CITY of NOVI CITY COUNCIL

Agenda Item 2
August 8, 2016

SUBJECT: Approval of the request of The Ivanhoe Companies for Beacon Hill, JSP 15-08, with Zoning Map Amendment 18.710, to rezone property in Section 12, located on the northeast corner of Twelve Mile Road and Meadowbrook Road from RA (Residential Acreage) to R-4 (One-Family Residential) and B-3 (General Business), subject to the related Planned Rezoning Overlay (PRO) Agreement, and corresponding PRO Plan. The property is approximately 21.13 acres. The applicant is proposing a 42-unit single-family residential development with frontage on and access to Meadowbrook Road, up to 22,000 square feet of commercial space with frontage on Twelve Mile Road, and an open space/park area at the corner of the intersection.

PROJECT NUMBER
13021-1
SHEET NAME
Conceptual Restoration Program
SHEET NUMBER
W-1

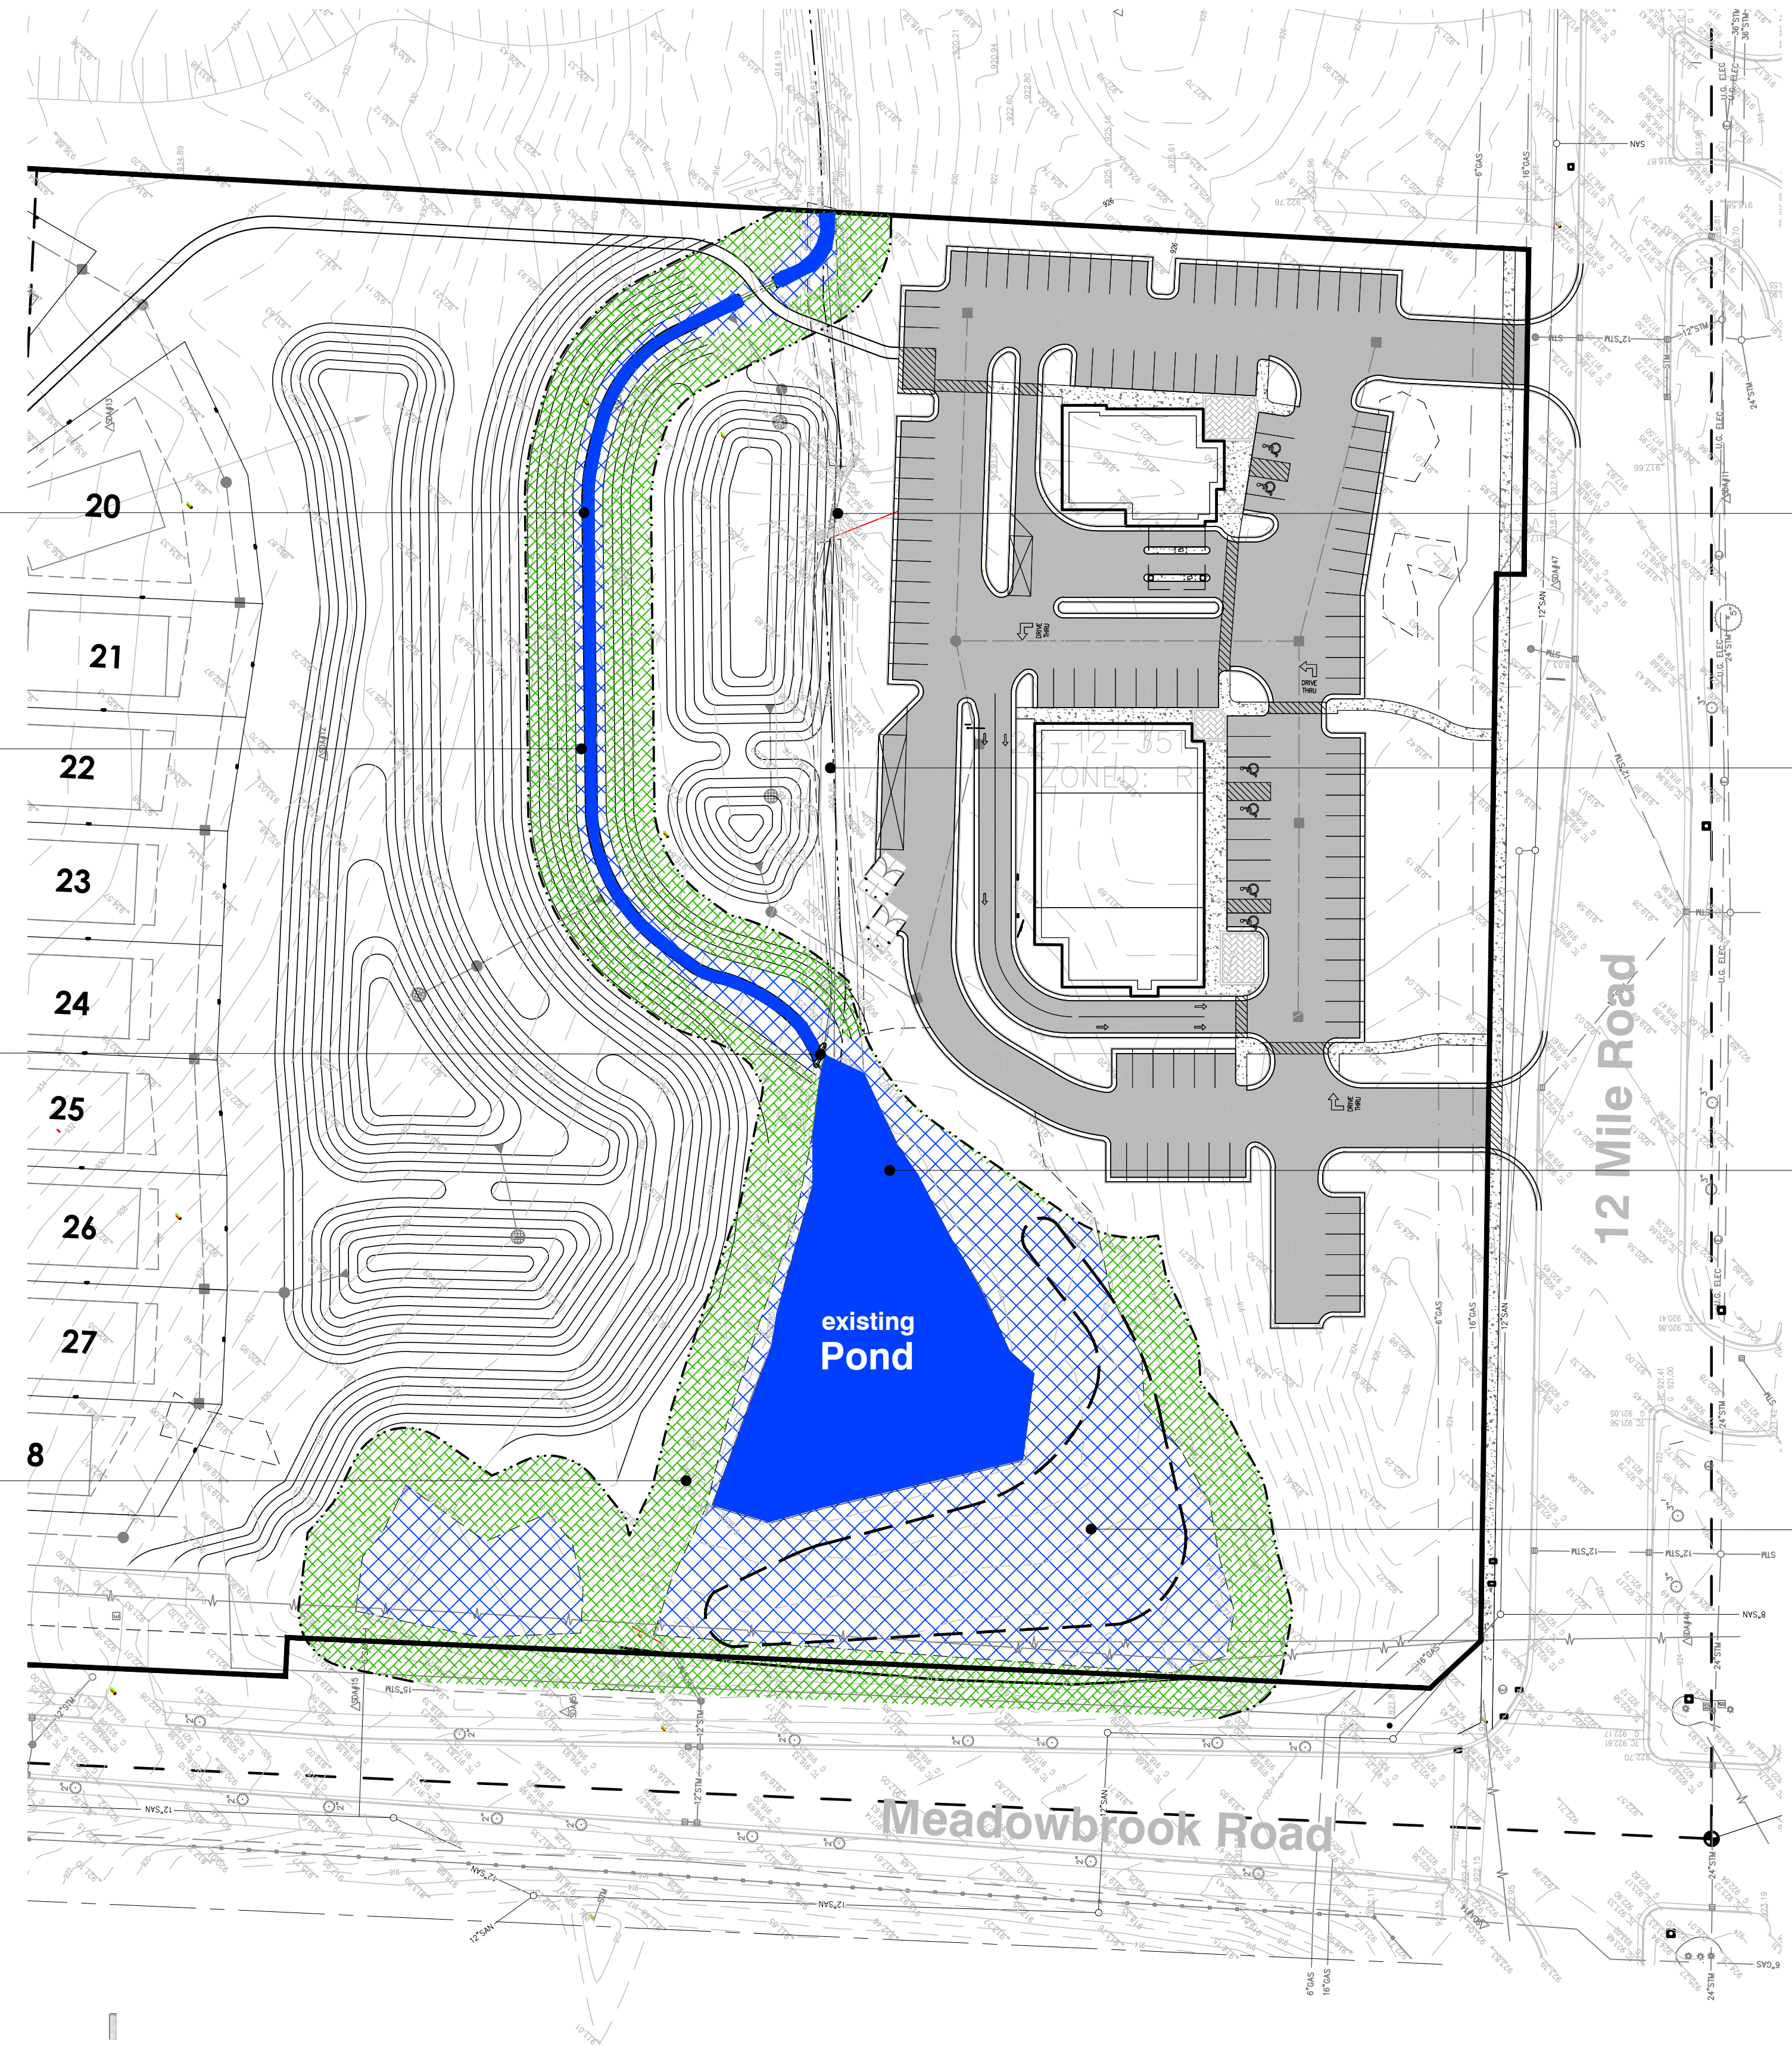
The Plan also proposes to abandon approximately 350 lineal feet of the existing stream channel (Wetland F). The stream will be relocated via approximately 485 lineal feet of constructed stream channel design. The following table summarizes the existing wetlands and the proposed wetland impacts as listed on the *Wetland & Buffer Impact Plan* (Sheet SP-14):

7A Beacon Hill Park Trailhead -tree replacement planting detail

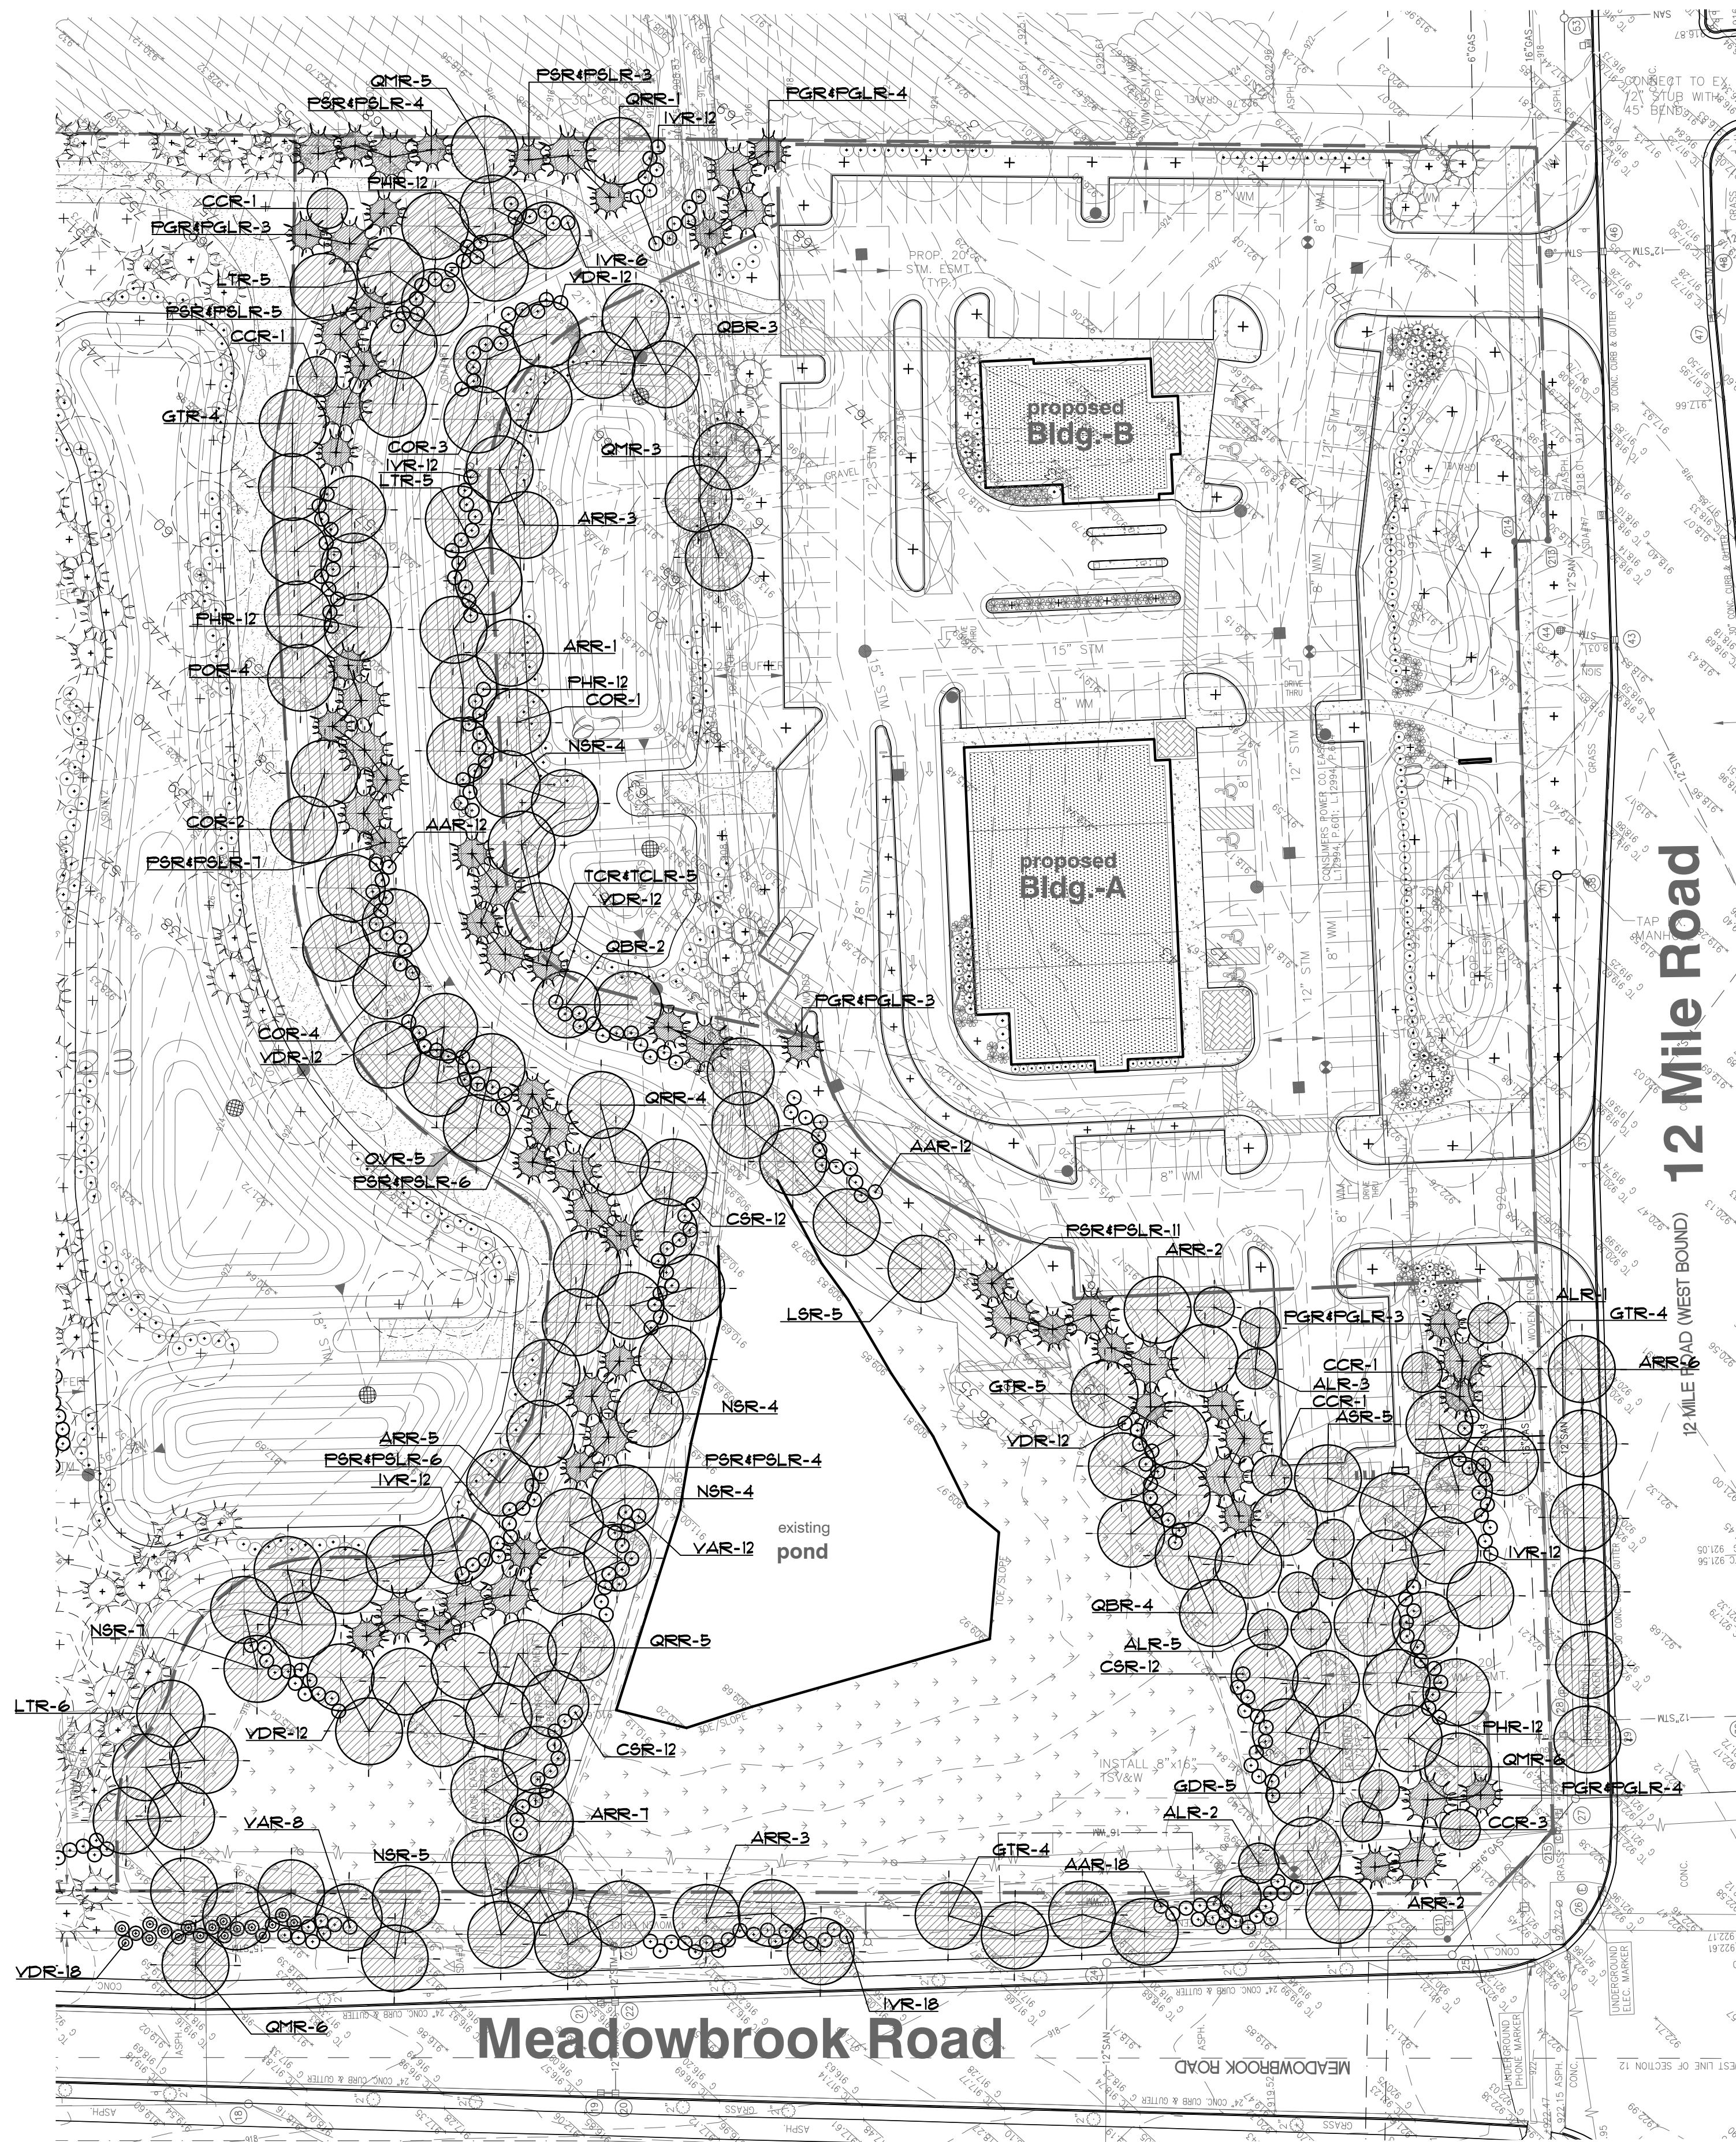
The following table (Table 1) summarizes the proposed Woodland Impacts. This information is from Sheet LS-7 of 7:

The current plan also includes a *Tree Replacement Plan Material List* on Sheet LS-7 of 7. This applicant has provided a list of proposed deciduous and coniferous trees as well as shrubs that are intended to meet the Woodland Replacement credit requirements. The proposed species all appear to be acceptable.

Figure 1. City of Novi Regulated Wetland & Woodland Map (approximate property boundary shown in red). Regulated Woodland areas are shown in green and regulated Wetland areas are shown in blue).

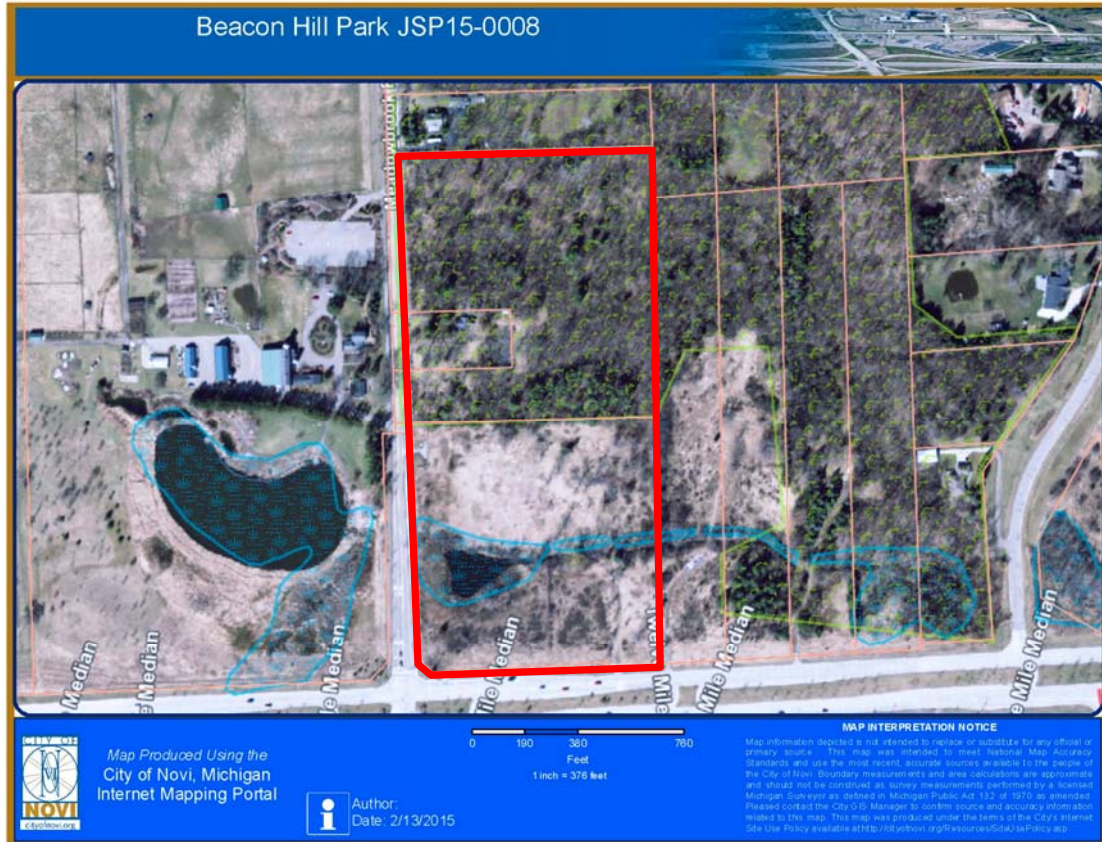
The entire site is approximately 20 acres, with City-regulated Woodland mapped across approximately the northern half of the project site (see Figure 1). A portion of the southern half of the site contains previously-disturbed/cleared land located along Twelve Mile Road. The highest quality woodlands on site are found in the northern section of the site. Some of these areas also contain regulated wetlands (i.e. forested wetland area located along the northern project boundary). It appears as if the proposed site development will involve a significant amount of impact to regulated woodlands and will include a significant number of tree removals.

Figure 3. RCOC Figure 6-3, Warrants for Right Turn Lane or Taper

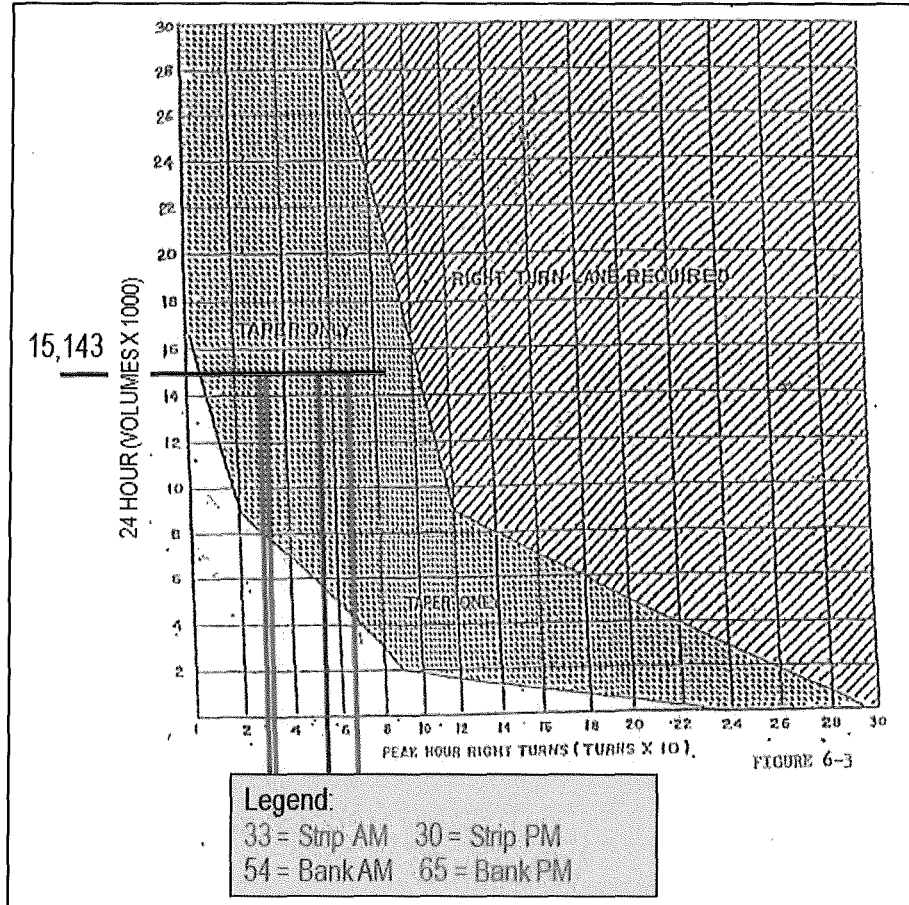
HRC conducted an analysis of the need for a right lane or taper at the development driveways using Figure 6-3 from the RCOC *Permit Rules, Specifications And Guidelines, adopted March 14, 2013*. There is no need for a right turn lane or taper for northbound Meadowbrook Road at the proposed residential driveway. The two commercial driveways on westbound 12 Mile do meet the warrants for a right turn taper. See Figure 3.
